AGENDA

PLANNING AND ZONING COMMISSION

January 19, 2016 - Tuesday

Figure 2
Removal Activity Map

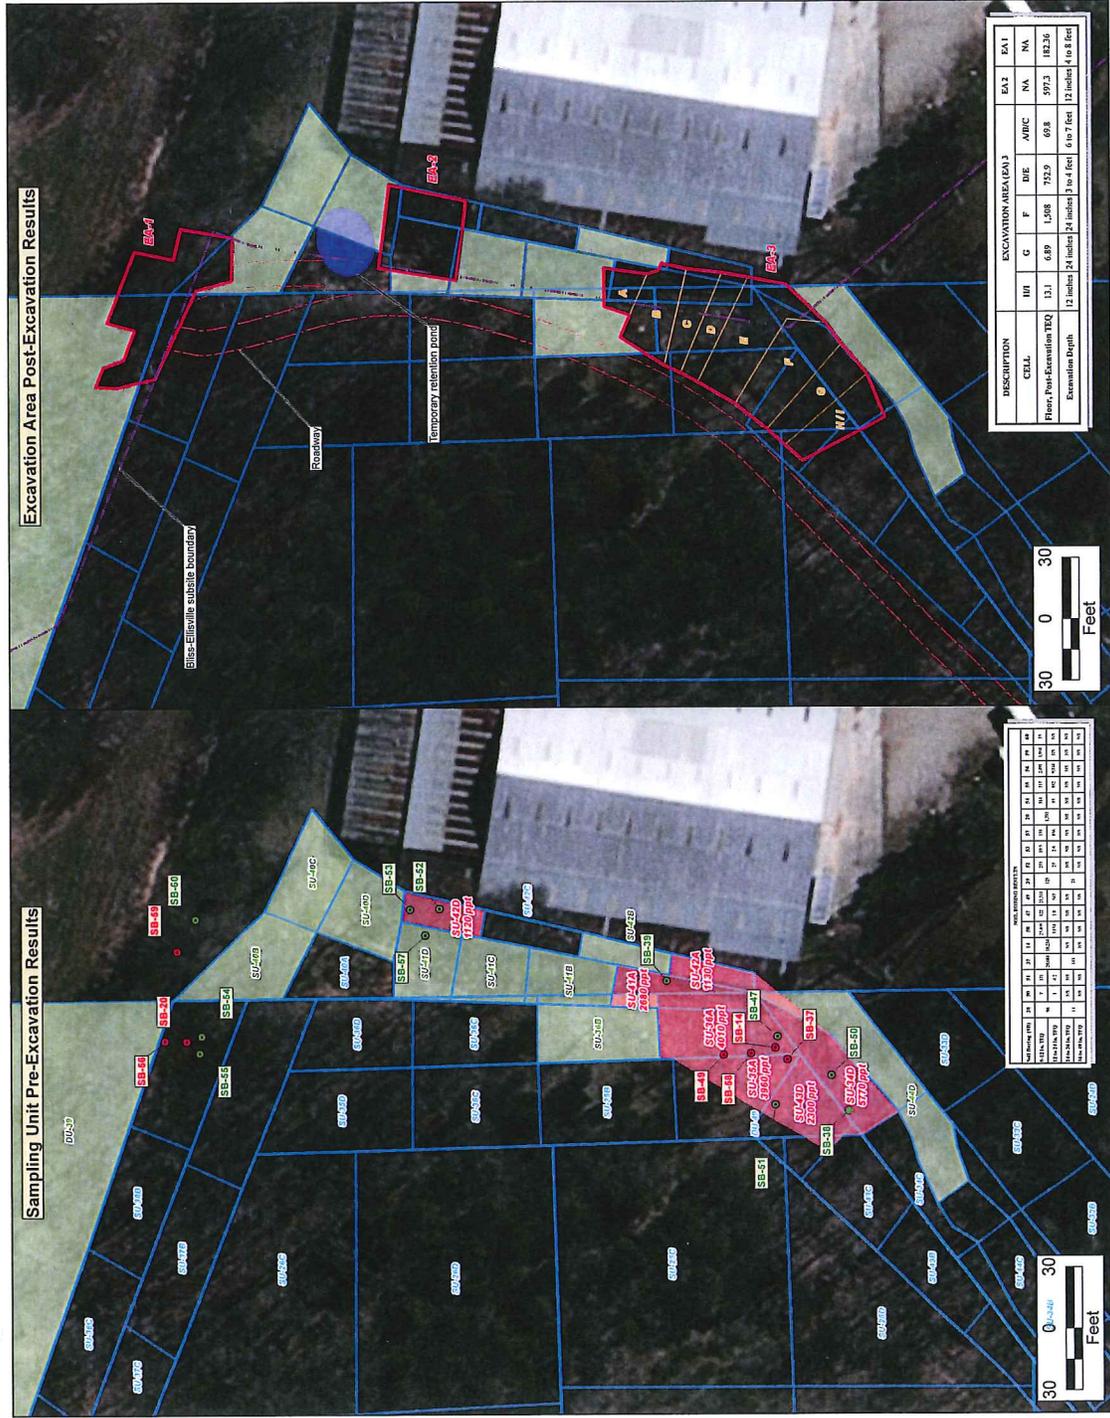
- g. Fig. 2 Pre-Excavation
 - i. Please add a triangle illustrating EA-1.
 - ii. Soil Boring table is illegible.
 - h. Fig. 2 Post-Excavation
 - i. Please illustrate NPL line in bright color.

- ii. Please add the 4 cell letters to EA-2.
 - iii. Please clarify EA-1 with Table 3 since it's an odd shape with 4 north walls.
 - i. Fig. 3
 - i. Please illustrate NPL line in bright color.
